UNITED STATES PATENT AND TRADEMARK OFFICE

APPLICATION NO.	FILING DATE	FIRST NAMED INVENTOR	ATTORNEY DOCKET NO.	CONFIRMATION NO.
10/597,861	04/10/2007	Giuseppe Giordano		7254

Office Action Summary

DETAILED ACTION

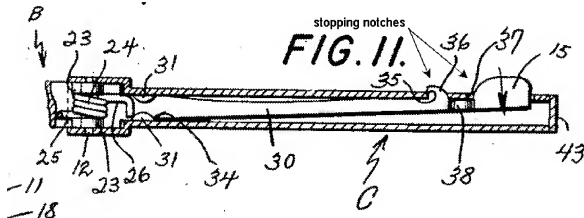
Claims 1-3 have been rejected under 35 U.S.C. 102(b) as being clearly anticipated by Kostka, 2555196.

Regarding claim 3, see annotated drawing showing the stopping notches.
